Subject: McGuire Nuclear Station Unit 2
Docket No. 50-370
Relief Request 01-009

RELIEF REQUEST 01-009

McGuire Nuclear Station - Unit 2

SECOND 10-YEAR INTERVAL REQUEST FOR RELIEF NO. 01-009

Component ID/Weld No. ZNC2FW53-25

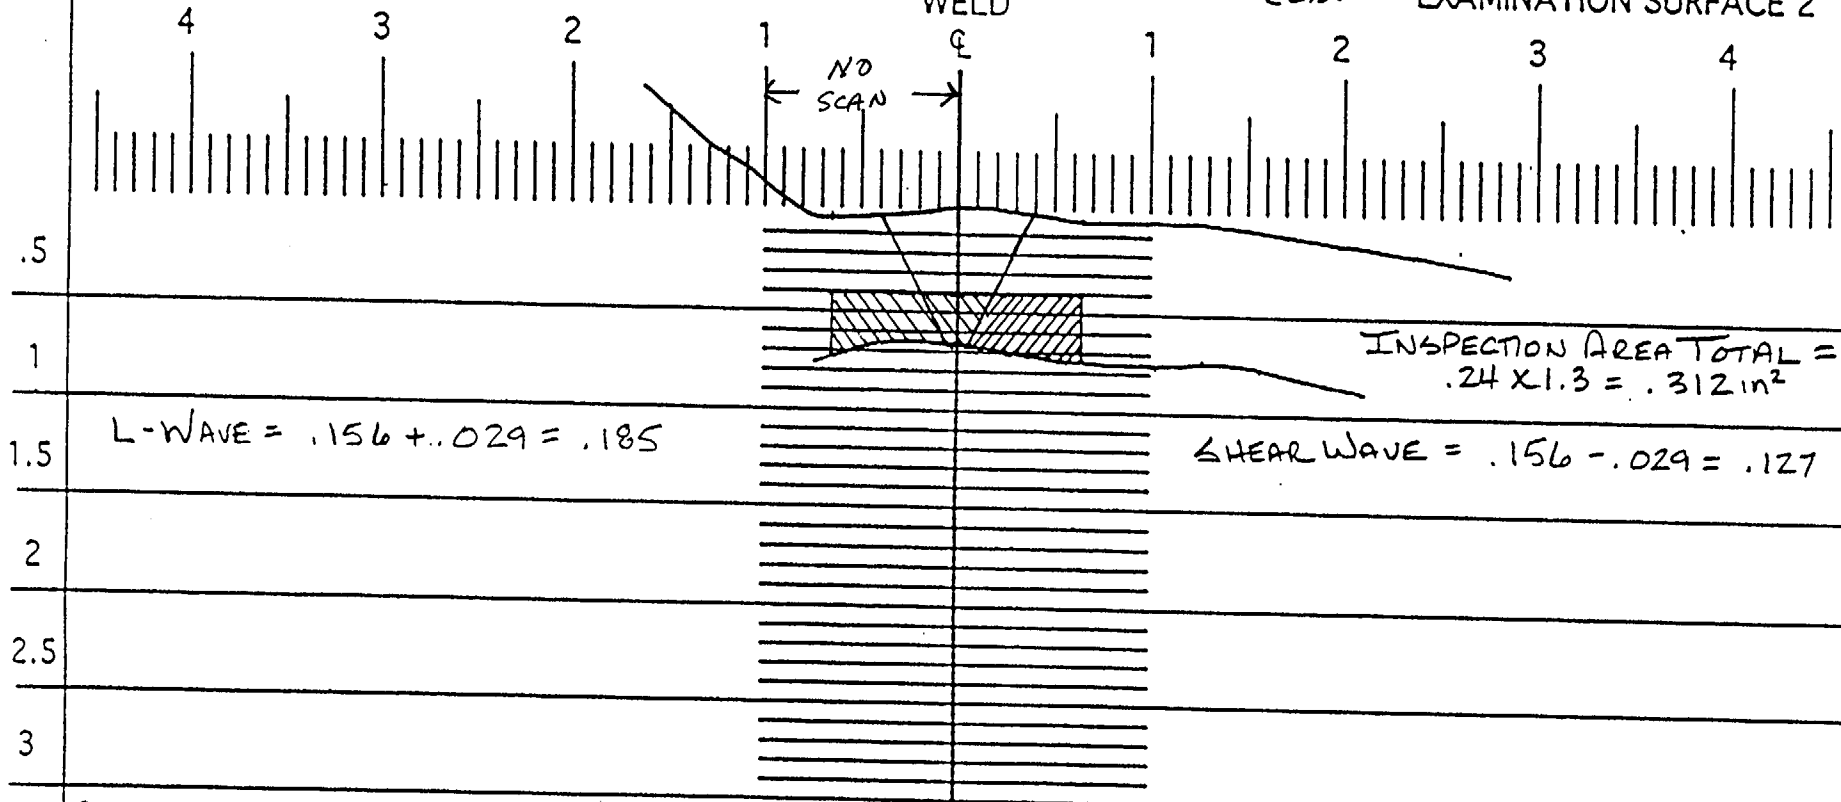
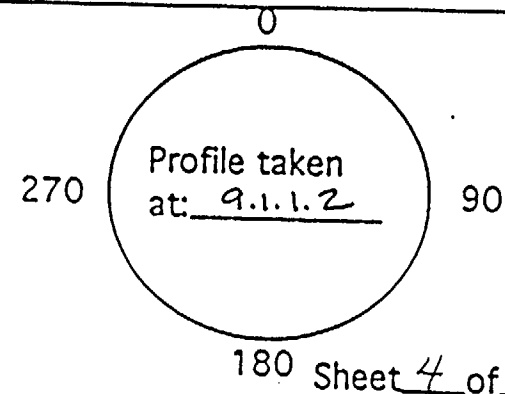
During the ultrasonic examination of this weld, greater than 90% of the required examination volume as allowed by Code Case N-460 could not be achieved. As shown in Attachment 1, (Pages 1-4) the examination coverage was limited to 60.30% of the required examination volume. This is an austenitic stainless steel elbow-to-flange weld where access is limited to the pipe side of the weld only. The percentage of coverage reported represents the aggregate coverage obtained from one scan parallel to the pipe axis and two scans, 180° apart in the circumferential direction. The weld design prevented any axial scan from the flange side. In order to achieve more coverage the weld would have to be re-designed to allow scanning from both sides.

DUE TO FLANGE CONFIGURATION

Component ID/Weld No. 2NC2FW53-37

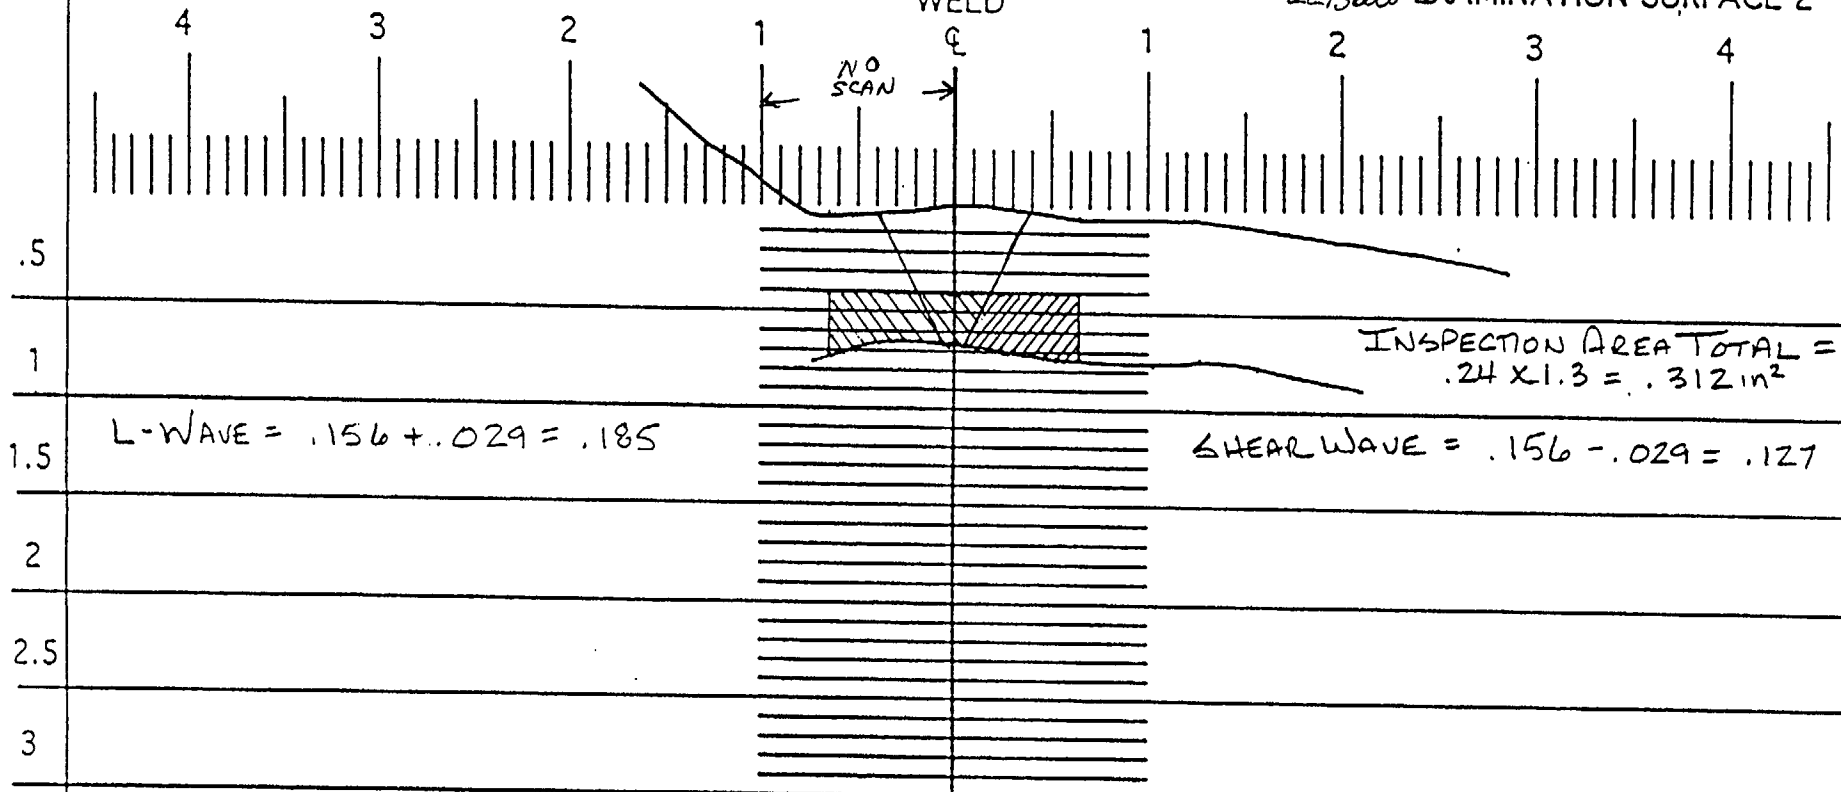
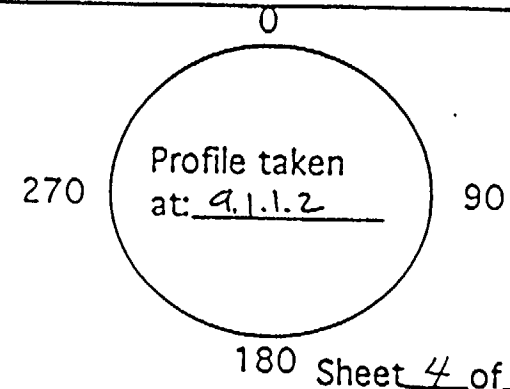
During the ultrasonic examination of this weld, greater than 90% of the required examination volume as allowed by Code Case N-460 could not be achieved. As shown in Attachment 1, (Pages 5-8) the examination coverage was limited to 60.30% of the required examination volume. This is an austenitic stainless steel elbow-to-flange weld where access is limited to the pipe side of the weld only. The percentage of coverage reported represents the aggregate coverage obtained from one scan parallel to the pipe axis and two scans, 180° apart in the circumferential direction. The weld design prevented any axial scan from the flange side. In order to achieve more coverage the weld would have to be re-designed to allow scanning from both sides.

2 NI 2 F 471

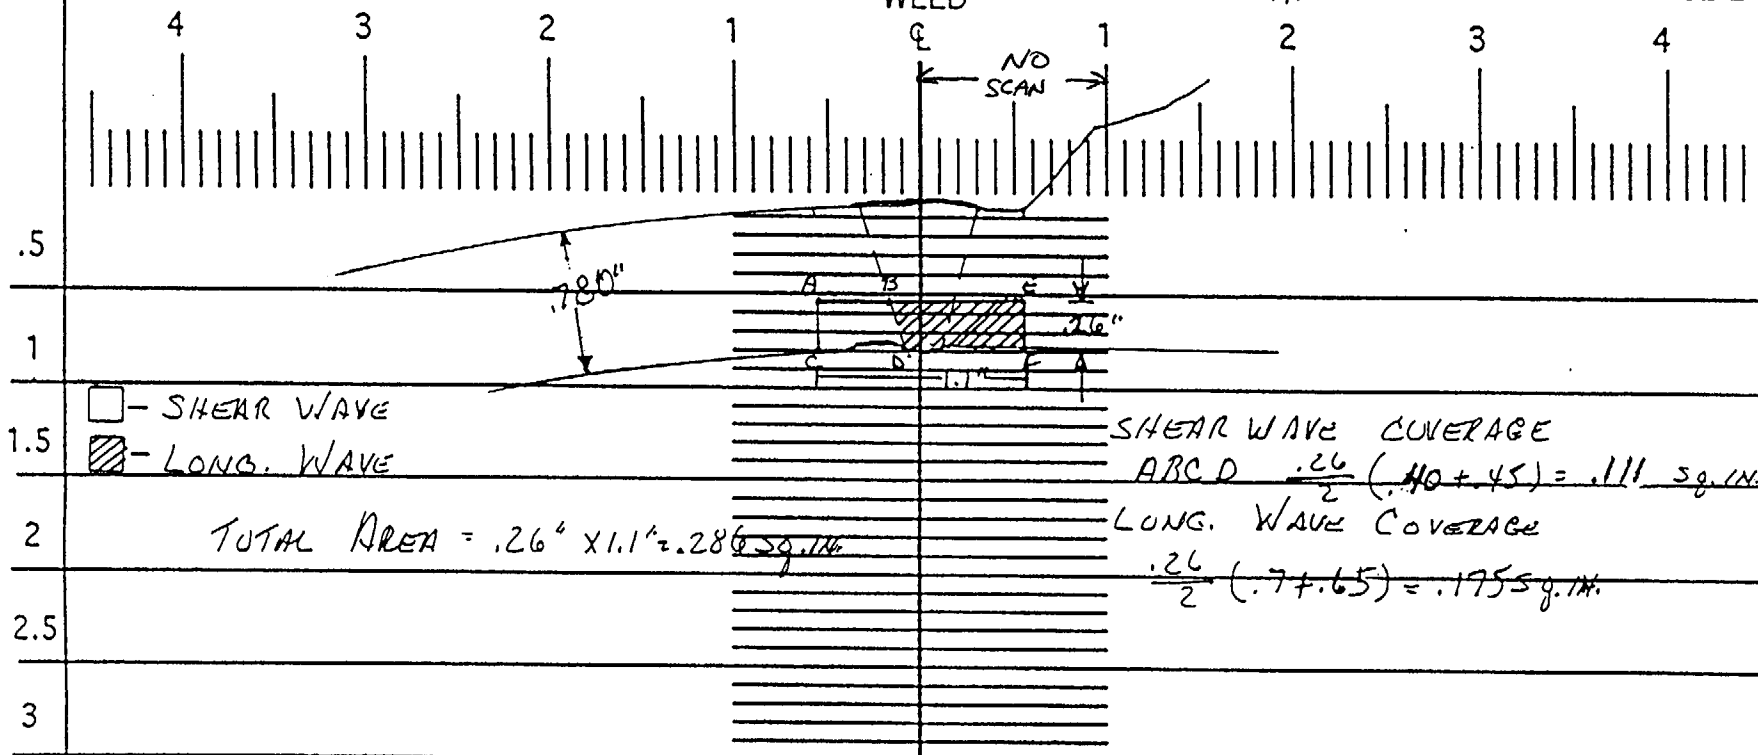
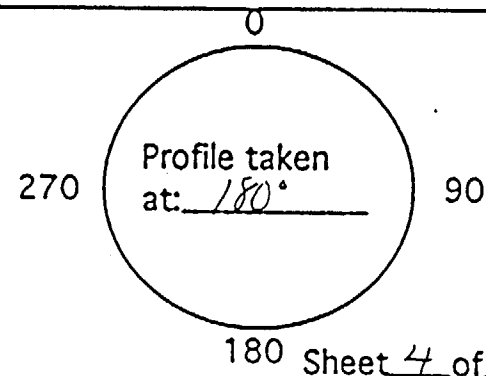
During the ultrasonic examination of this weld, greater than 90% of the required examination volume as allowed by Code Case N-460 could not be achieved. As shown in Attachment 1, (Pages 9-12) the examination coverage was limited to 59.70% of the required examination volume. This is an austenitic stainless steel elbow-to-valve weld where access is limited to the elbow side of the weld only. The percentage of coverage reported represents the aggregate coverage obtained from one scan parallel to the pipe axis and two scans, 180° apart in the circumferential direction. The weld design prevented any axial scan from the valve side. In order to achieve more coverage the weld would have to be re-designed to allow scanning from both sides.

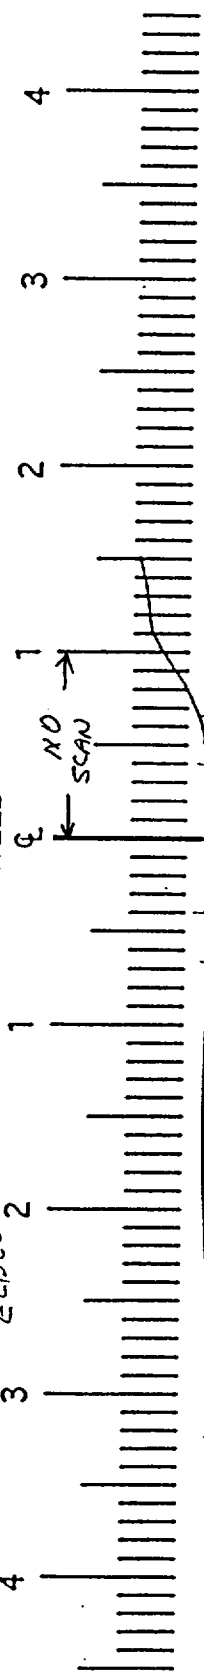
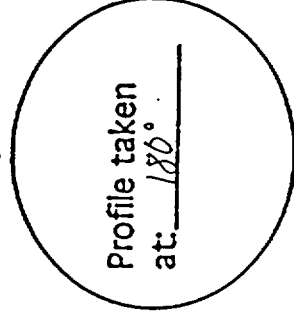
During the ultrasonic examination of this weld, greater than 90% of the required examination volume as allowed by Code Case N-460 could not be achieved. As shown in Attachment 1, Pages 13-16, the examination coverage was limited to 59.61% of the required examination volume. This is an austenitic stainless steel elbow-to-valve weld where access is limited to the elbow side of the weld only. The percentage of coverage reported represents the aggregate coverage obtained from one scan parallel to the pipe axis and two scans, 180° apart in the circumferential direction. The weld design prevented any axial scan from the valve side. In order to achieve more coverage the weld would have to be re-designed to allow scanning from both sides.
